UNITED STATES PATENT AND TRADEMARK OFFICE

APPLICATION NO.	FILING DATE	FIRST NAMED INVENTOR	ATTORNEY DOCKET NO.	CONFIRMATION NO.
09/780,480	02/12/2001	Akira Senoo	Q62848	8117

# Office Action Summary

## DETAILED ACTION

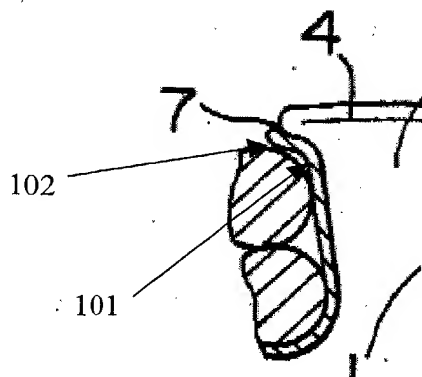
Honshima et al. clearly teaches the construction of an armature for an electric rotary machine, the armature comprising:

an armature core (2) provided with a plurality of slots (1) extending in an axial direction and disposed alongside each other in a circumferential direction;

an armature winding (3) inserted in the slots so as to be mounted on the armature core; and

an insulator (6) mounted in each of the slots wherein:

the insulator is disposed between an inner face of each slot and the armature winding (Figures 1, 2A, 2D, 4, 5A and 5B); and

first creases (101, added by the examiner) are formed on side portions of each insulator so as to extend in a lengthwise direction of the slot at a slot-opening end of the side portions, the first creases being formed by first bent parts for angling the slot-opening ends of the side portions so as to be apart from each other.<sup>1</sup>

7. With regards to claim 11, Honshima et al. disclose second creases (102, added by the examiner) are formed on the side portions of each insulator so as to extend in a lengthwise

direction of the slot at a location closer to the slot-opening end than the first creases, the second creases being formed by second bent parts for angling the slot-opening ends of the side portions toward each other.

8. With regards to claim 13, Honshima et al. disclose the side portion of each insulator expand in a circumferential direction at the bottom ends of the side portions of the insulator, thereby coming into close contact with inner faces of the slot toward the bottom thereof as shown in Figures 1, 2A, 2D, 4, 5A and 5B.
